Posted
Amdt. 116
to DPR-52

The Commission has issued the enclosed Amendment Nos. 121, 116 and 92 to Facility Operating License Nos. DPR-33, DPR-52 and DPR-68 for the Browns Ferry Nuclear Plant, Units 1, 2 and 3. These amendments are in response to your application dated September 22, 1983 (TVA BFNP TS 191), as supplemented March 20, 1985.

These amendments revise the present pressure-temperature limit curves (Figure 3.6-1) in the Technical Specifications to provide more conservative limiting temperatures for pressure test, heatup, cooldown and core operations which are valid for 12 equivalent full power years of plant operation. On April 12, 1985, we had issued Amendment No. 87 for Browns Ferry Unit 3 which, as an interim measure, had approved the same identical curves for the duration of the present Cycle 6 operations.

SAFETY EVALUATION BY THE OFFICE OF NUCLEAR REACTOR REGULATION

Figure 3.6-1

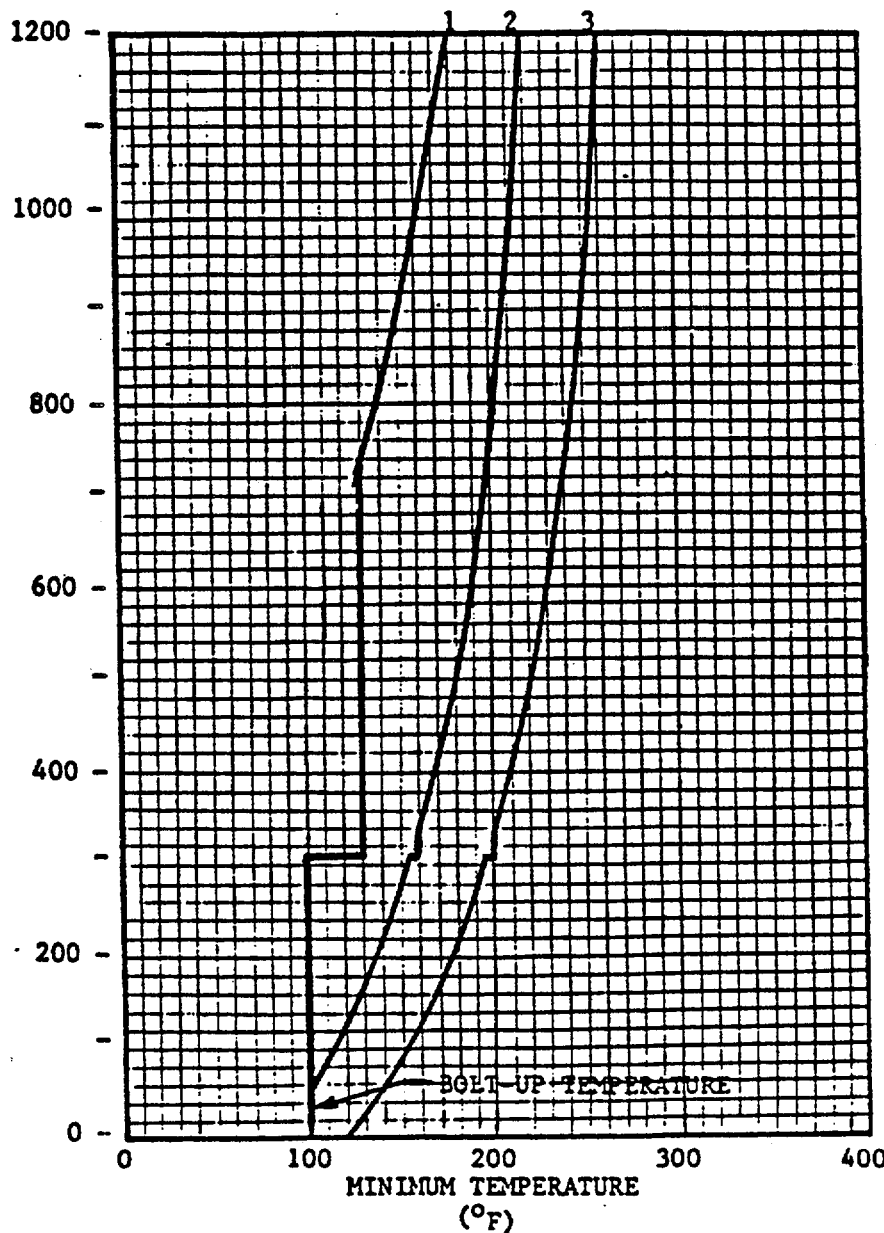
The fracture toughness of all ferritic steels gradually decreases with exposure to fast neutrons above a threshold value. To adjust for this, the minimum operating temperature vs. pressure curves need to be revised. The present curves in Figure 3.6-1, which were based on a shift in RT_{NDT} of 30 F, were approved for use through 4.0 EFPY. The Browns Ferry reactor vessels have exceeded this exposure. By application dated September 23, 1983, the licensee proposed revised curves. Our review of this submittal determined that additional information (as described in our letter of January 23, 1984) was needed on the chemical composition and test results on the weld and plate material used to fabricate the reactor vessels. The information requested was provided by TVA'S letter of March 20, 1985. The March 20, 1985 submittal provided clarifying information to support the licensee's materials evaluation and did not significantly change the initial application. Based on the irradiation data, TVA concludes that a 45°F shift in RT_{NDT} will not occur for at least 12 EFPY of operation. This would cover about the next decade of operation for each Browns Ferry unit.

Minimum temperature for pressure tests such as required by Section XI. Minimum temperature of 170°F is required for test pressure of 1,100 psig.

Minimum temperature for mechanical heatup or cooldown following nuclear shutdown.

Minimum temperature for core operation (criticality) includes additional margin required by 10CFR50, Appendix G, Par. IV.A.3 which became effective July 26, 1983.

These curves include sufficient margin to provide protection against feedwater nozzle degradation. The curves allow for shifts in RTNDT of the reactor vessel beltline materials to compensate for radiation embrittlement for 12 EFY.

Figure 3.6-1

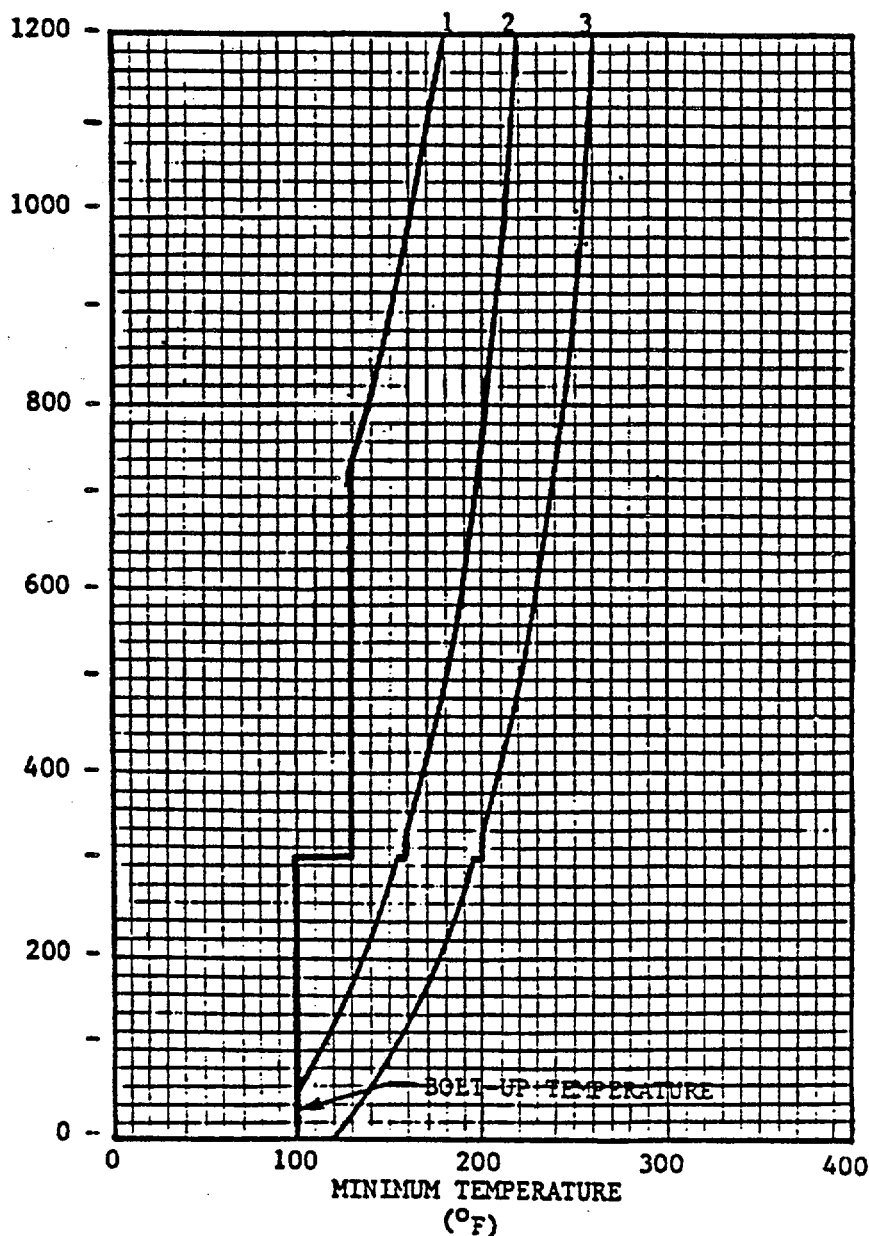
missing from Section 3.6.A.2 of the Unit 3 TS compared to Units 1 and 2. Specifically, this section in the Units 1 and 2 TS reads: "During all operations with a critical core, other than for low level physics tests, except when the vessel is vented, the reactor vessel shell and fluid temperatures shall be at or above the temperature of curve #3 of figure 3.6-1". The phrase that is missing in Section 3.6.A.2 of the Unit 3 TS is: "except when the vessel is vented". The phrase is properly included in Section 3.6.A.3 of the Unit 3 TS. The NRC resident inspectors had also noted this in a recent inspection report. This phrase was in the original Unit 3 TS. Our review indicates the phrase was inadvertently dropped when page 185 was retyped to modify Section 3.6.A.3 in Amendment 56 issued July 22, 1982, and was not part of the changes intended to be authorized by that Amendment. The licensee agreed that this error in omission should be corrected to clarify a possible violation and to have the TS for all three units the same (and correct). By agreement with the licensee, we are adding the phrase "except when the vessel is vented" back to Section 3.6.A.2 of the Unit 3 TSs to correct this error.

Curve #1
Minimum temperature for pressure tests such as required by Section XI. Minimum temperature of 170°F is required for test pressure of 1,100 psig.

Curve #2
Minimum temperature for mechanical heatup or cooldown following nuclear shutdown.

Curve #3
Minimum temperature for core operation (criticality) includes additional margin required by 10CFR50, Appendix G, Par. IV.A.3 which became effective July 26, 1983.

Notes
These curves include sufficient margin to provide protection against feedwater nozzle degradation. The curves allow for shifts in RTNDT of the reactor vessel beltline materials to compensate for radiation embrittlement for 12 EFPY.
